NAVIGATION AND VESSEL INSPECTION CIRCULAR NO. 4-85 CHANGE 2

Subj: Change 2 to NVIC 4-85 of 29 May 1985, Recalls and Other Corrective Measures for Lifesaving and Fire Protection Equipment

1. PURPOSE. This Circular updates Navigation and Vessel Inspection Circular No. 4-85, by adding new enclosures describing recent recall and corrective actions.

Figure 1 of Enclosure(22) to NVIC 4-85 CH-2

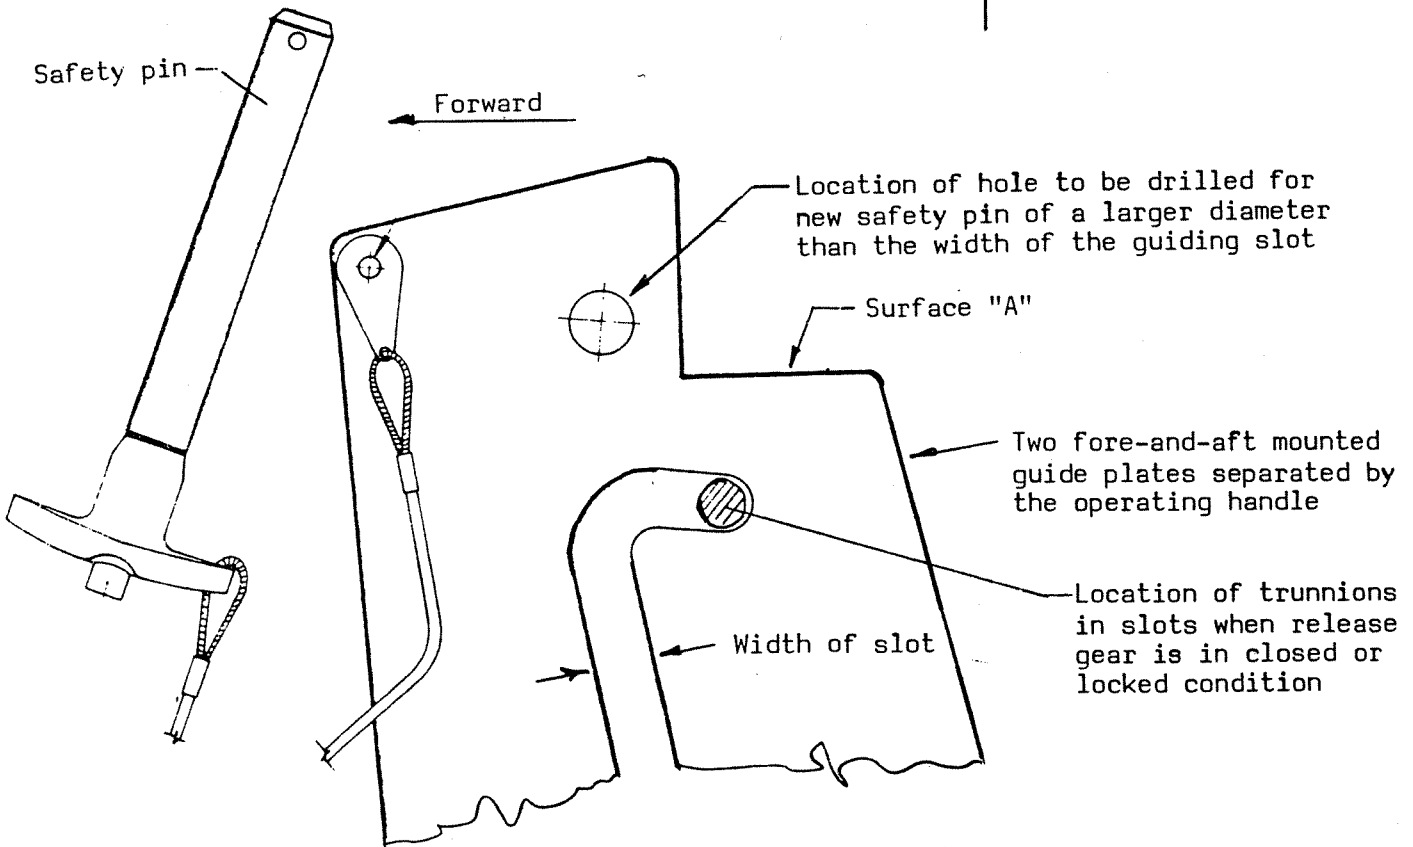
1. PROBLEM. The safety pin for the Viking release gear operating handle used in certain Watercraft America lifeboats, can be accidentally inserted into the slot for the release handle trunnion, rather than the hole intended for the safety pin. If this is done, the release gear is not in a safe condition.

2. DISCUSSION. Watercraft America, Inc. has developed a modification to prevent the accidental insertion of the safety pin before the handle is in the fully closed position. Viking release gear with approval numbers 160.033/66/0, 160.033/66/1, and 160.033/66/2 must be modified by drilling out the safety pin hole and replacing the original safety pin with a larger one.

3. ACTION.
 - a. Vessel and MODU operators having Watercraft America lifeboats equipped with Viking gear having approval numbers 160.033/66/0, 160.033/66/1, or 160.033/66/2 shall make sure the release gear is modified in accordance with Watercraft America drawing SP204 dated May 2, 1986. The Coast Guard Officer in Charge of Marine Inspection shall be notified before the modification work begins. The drawing and instruction may be obtained from:

Watercraft America, Inc.
P.O. Box 1130
Edgewater, FL 32032
(904) 428-5781
Telex: 567415
 - b. Coast Guard inspectors will require modification of Watercraft America Viking release gear with approval numbers 160.033/66/0, 160.033/66/1, or 160.033/66/2 in accordance with the Watercraft America drawing and instruction.

Figure 1 of Enclosure(23) to NVIC 4-85 CH-2

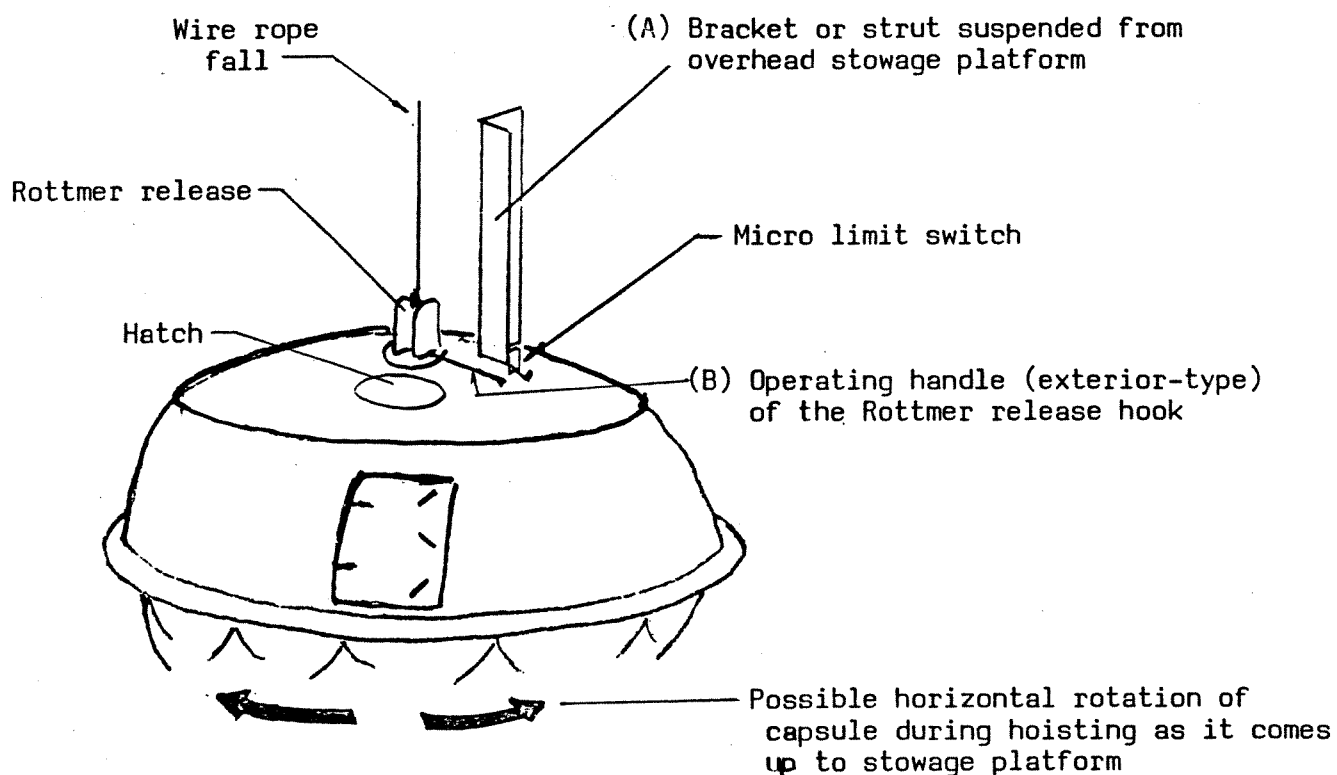
1. PROBLEM: Some launching devices for Whittaker Survival capsules may have been modified by the unauthorized addition of brackets to hold microswitches or other devices added by the owner or operator.

2. DISCUSSION: The unauthorized modifications may appear to be almost identical to the brackets that hold the limit switches which are part of the approved launching system. If brackets are added and not carefully located, they can engage the cable and sector operating mechanism on those capsules equipped with Rottmer type hooks. This has happened on two separate occasions, resulting in the accidental opening of the hook and dropping of the capsule. Any person on board the capsule is at risk of being seriously injured.

NOTE: The above arrangement has the danger of letting the operating handle(B) of the Rottmer release to push against the bracket(A) suspended from under the stowage platform. This could result from the horizontal rotation of the capsule as it comes up into the stowed position. This unintended interference is a potential hazard because of the chance that the operating handle(B) could be moved from its locked position, thus permitting the capsule to drop free of the wire rope fall.

3. ACTION: Servicing personnel and Coast Guard inspectors should make sure that any brackets on Whittaker capsule launching devices are part of the approved system or are approved modifications. Generally, the only brackets coming close to the surface of the capsule should be those holding the limit switches which prevent the capsule from being winched into the stops under motor power. Any others should be considered suspect, unless the owner or operator can show that they are approved additions. Any unauthorized modifications of this type must be removed. Questions on whether or not such brackets are approved can be answered by the manufacturer:
